Groundwater Transfer Review Summary Form

Transfer/PA # T- 14866

Ground Water Review Form:

Application: T-14866

Figure 2: Hydrograph

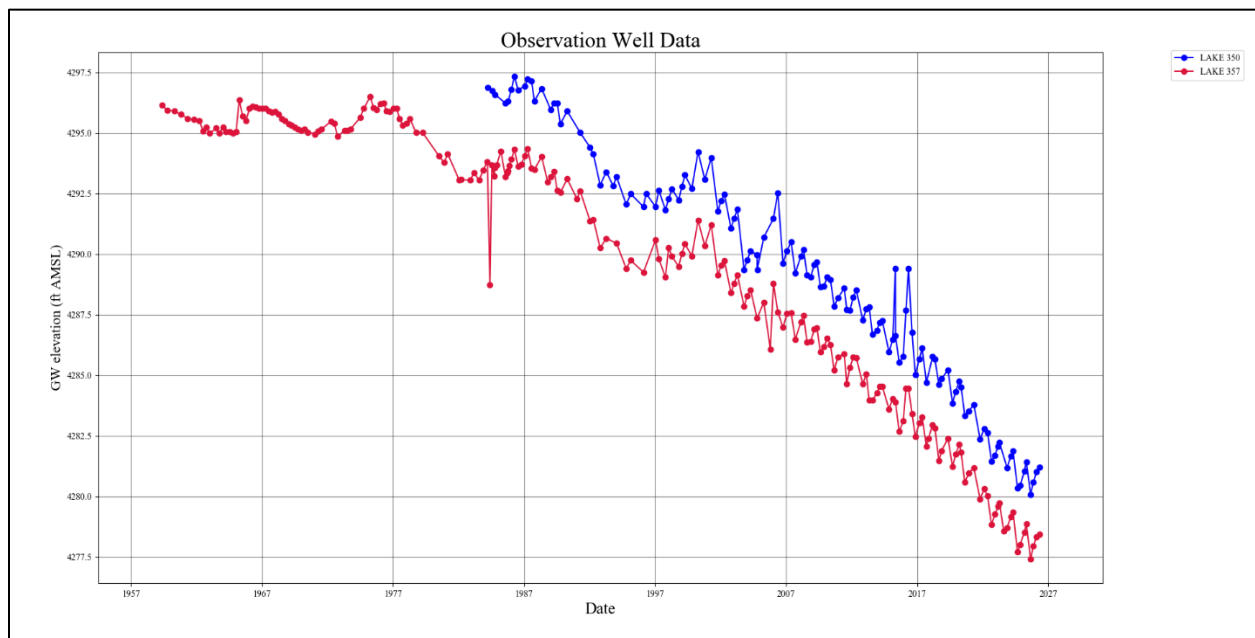
3. a) Is the existing authorized POA subject to a water level decline condition?
☐ Yes ☒ No Comments: No decline conditions associated with Certificate 41331, but a hydrograph is provided as Figure 2 at the end of the document.

LAKE 350 has had consistent measurements since 1984 and shows a decline of approximately 0.57 ft/ year since May 2006. LAKE 357 is a nearby state observation well that tracks with LAKE 350 and has a longer period of record that begins in 1959.

Figure 3: Theis Drawdown

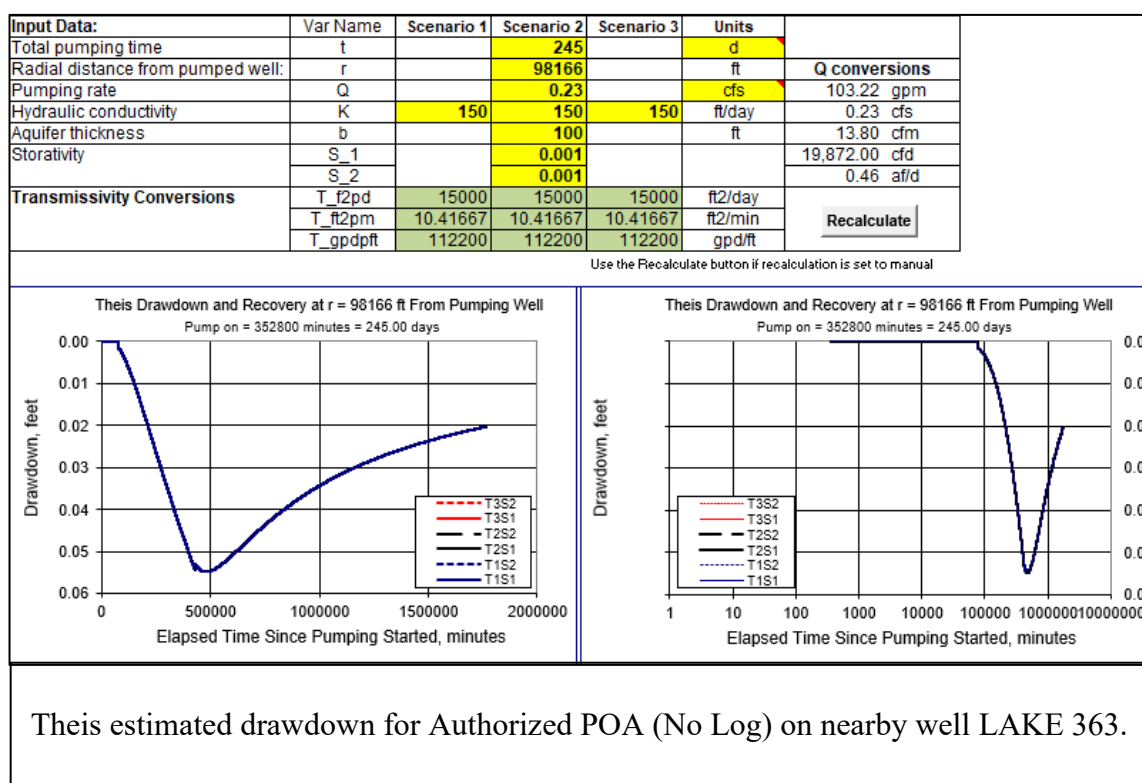
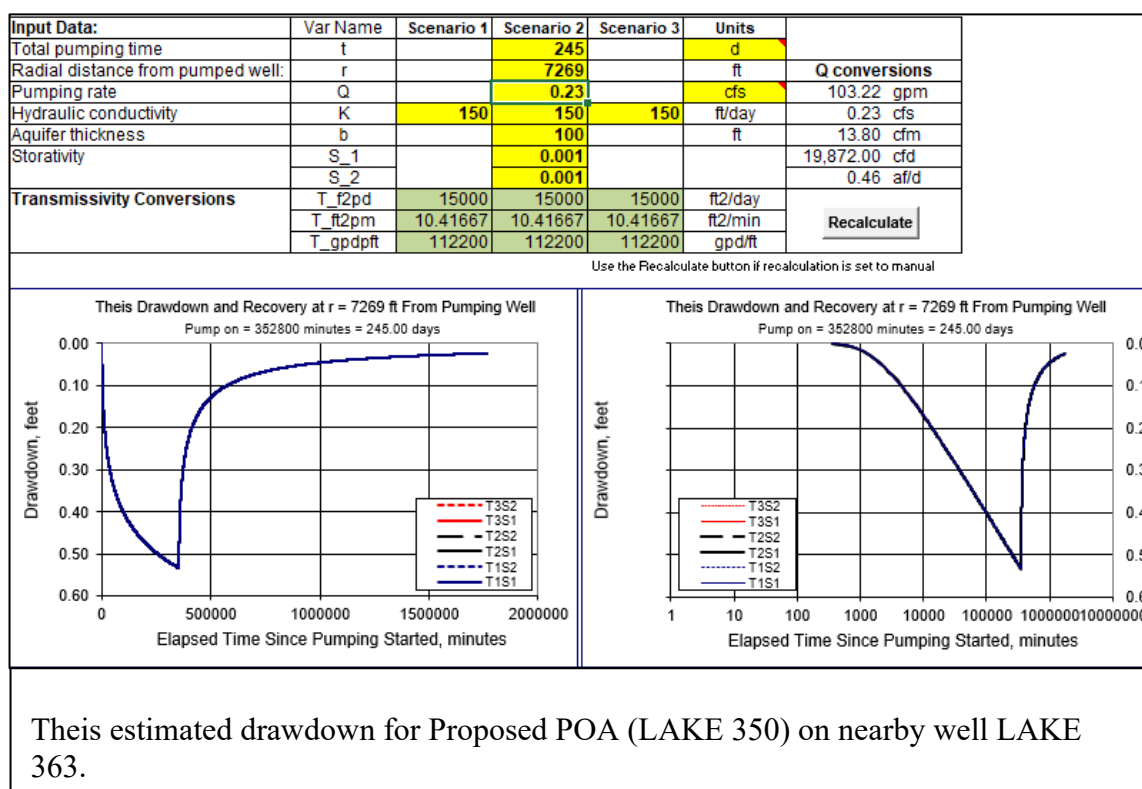
5. a) Will this proposed change, at its maximum allowed rate of use, likely result in an increase in interference with **another ground water right**?
☒ Yes ☐ No Comments: Proposed POA is moving 7269 ft away from LAKE 363, which is an irrigation well that is a POA for certificates 92359 and 98008.

- b) If yes, would this proposed change, at its maximum allowed rate of use, likely result in another groundwater right not receiving the water to which it is legally entitled?
☐ Yes ☒ No If yes, explain: A Theis drawdown analysis was performed for this proposed change in POA using an intermediate storage coefficient of 0.001, transmissivity estimate of 15,000 ft²/day from McFarland and Ryals (1991), and a maximum pumping rate of 0.23 CFS for a duration of 245 days. Considering pumping from both the proposed POA and the affected well, the estimated increase in drawdown from the proposed POA is 0.48 ft for a max drawdown of 3.13 ft. This increase in drawdown would not meet the standard of "substantial or undue interference". The Theis drawdown analysis is included as Figure 3.
